Source: Leece-Neville Heavy Duty Systems Division - Arcade, NY USA  
 Date: July 7, 2017  
 Bulletin No: TSB-1044  
 Models: 8LHA2094VA, 8LHA2071VA (110-555IJHO)  
 Subject: Wiring instructions to replace 8LHA2094VA with 8LHA2071VA (110-555IJHO)

**These instructions provide proper wiring connections required to replace the 8LHA-2094VA with an 8LHA2071VA (110-555IJHO).**

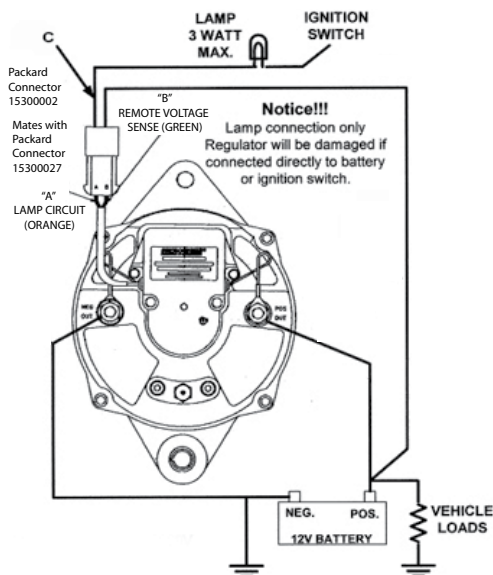
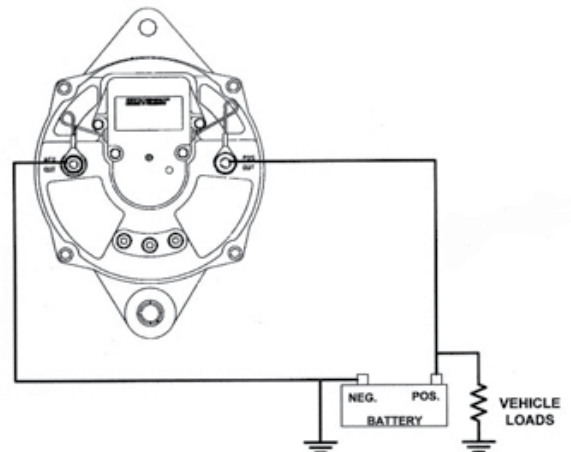
The 8LHA2094VA is equipped with a remote voltage sense connection as well as a lamp connection. The 8LHA2071VA (110-555IJHO) is a direct replacement, however, it does not incorporate a remote voltage sense connection point nor a lamp connection point.

When installing the 8LHA2071VA (110-555IJHO) as a direct replacement Positive Battery (B+) and Negative Battery (B-) connections are required. Remote voltage sense is not required and the alternator will function normally. There is no provision for a lamp connection and the dash lamp will no longer be operable.
